## PCI-SIG ENGINEERING CHANGE NOTICE

<b>TITLE:</b>	PCIe Link Activation
<b>DATE:</b>	Introduced: 17 May 2017 Updated: 7 December 2017 Final Approval: 7 December 2017
<b>AFFECTED DOCUMENT:</b>	PCI Express Base Specification, Revision 4.0
<b>SPONSOR:</b>	Intel Corp.

Figure 7-102: L1 PM Substates Capability

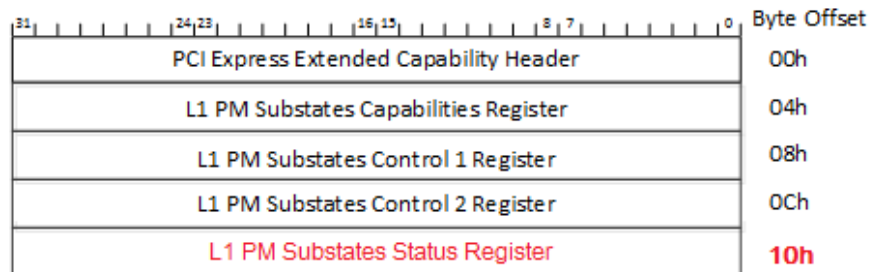
The PCI Express L1 PM Substates Capability is an optional Extended Capability, that is required if L1 PM Substates is implemented at a Port. The L1 PM Substates Extended Capability structure is defined as shown in Figure 7-102.

In Table 7-82, edit as shown:

Location	Register Description	Attributes
...	...	...
19:16	<p><b>Capability Version</b> – This field is a PCI-SIG defined version number that indicates the version of the Capability structure present.</p> <p><u>Must be 1h for this version of the specification.</u></p> <p><u>This field must be 2h if the L1 PM Substates Status Register is implemented and must be 1h otherwise.</u></p>	HwInit
...	...	...

Figure 7-103: L1 PM Substates Capabilities Register

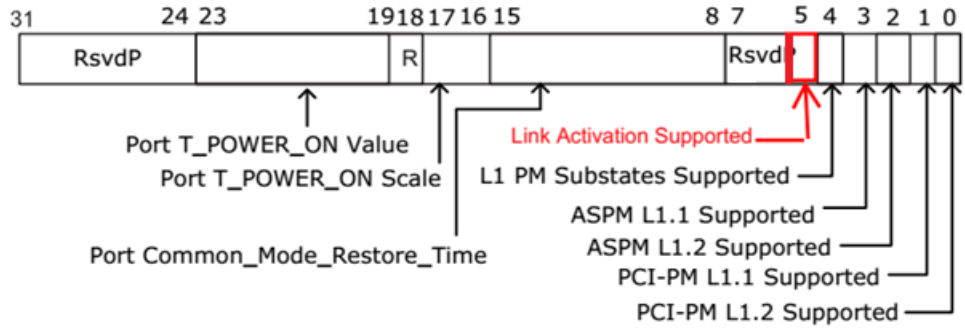
In Section 7.8.3.2, edit as shown:

Location	Register Description	Attributes
...	...	...
<u>5</u>	<u>Link Activation Supported – For Downstream Ports, when Set, this bit indicates that this Port supports Link Activation.</u> <u>This bit is of type RsvdP for Upstream Ports.</u>	<u>HwInit/RsvdP</u>
<u>7:6:5</u>	<b>Reserved</b>	RsvdP

Figure 7-104: L1 PM Substates Control 1 Register

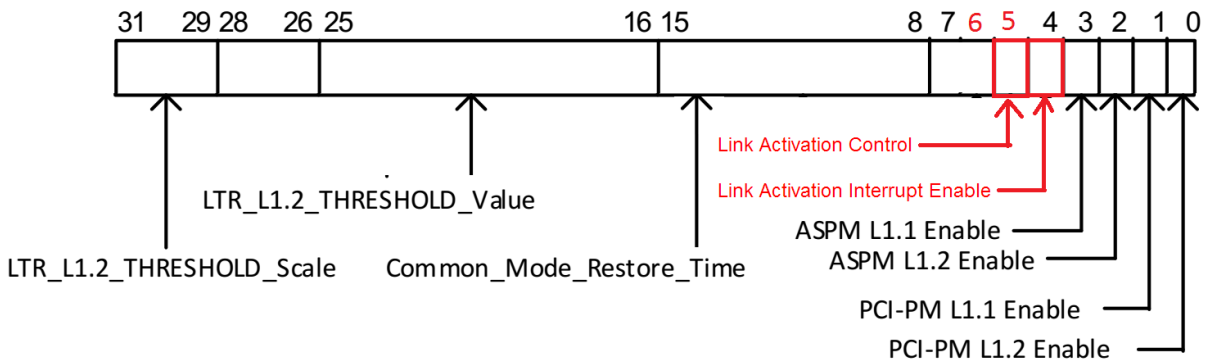
In Section 7.8.3.3, edit as shown:

Location	Register Description	Attributes
...	...	...
<u>4</u>	<p><b><u>Link Activation Interrupt Enable</u></b> – When set this bit enables the generation of an interrupt to indicate the completion of the Link Activation process. See Section 5.5.6 for details.</p> <p><u>Required for Downstream Ports when the Link Activation Supported bit is Set, otherwise it is permitted to be hardwired to 0b.</u></p> <p><u>Must be RsvdP for Upstream Ports.</u></p> <p><u>Default value is 0b.</u></p>	<u>RW/RsvdP</u>
<u>5</u>	<p><b><u>Link Activation Control</u></b> – When this bit is Set, the Port must initiate the Link Activation process. See section 5.5.6 for details</p> <p><u>Required for Downstream Ports when the Link Activation Supported bit is Set, otherwise it is permitted to be hardwired to 0b.</u></p> <p><u>Must be RsvdP for Upstream Ports.</u></p> <p><u>Default value is 0b.</u></p>	<u>RW/RsvdP</u>
<u>7:6</u>	<b>Reserved</b>	RsvdP
